**PLANNING, ZONING, & BUILDING DEPARTMENT**  
**PZ&B Staff Combination Memorandum: Architectural Commission and Town Council**

**SUBJECT:** ARC-24-022 (ZON-24-034) 726 HI MOUNT RD (COMBO)

**MEETING:** FEBRUARY 28, 2024, ARCOM  
MARCH 13, 2024, TC

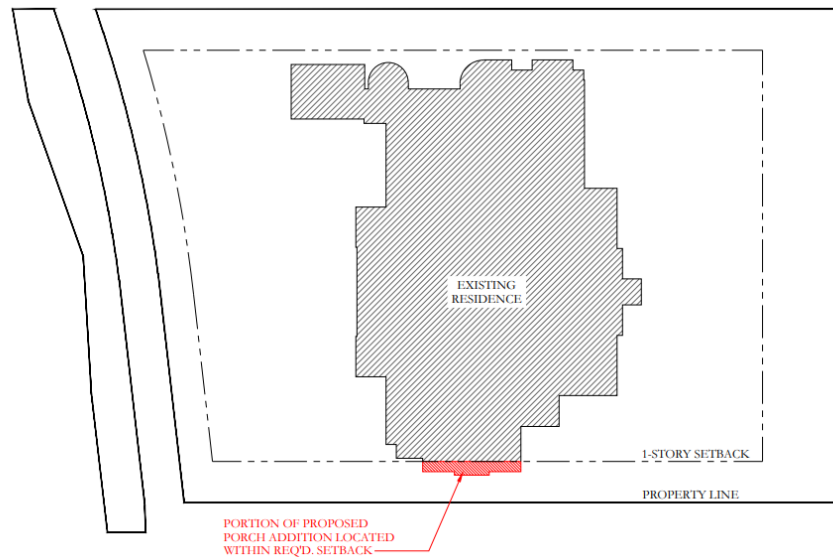
The application, as presented, requires one (1) variance for construction of the covered one-story porch addition. The applicant is proposing an 8.33' south side yard setback in lieu of the 12.5' required setback. The diagram below highlights the portion of the proposed porch addition that violates the setback requirements:
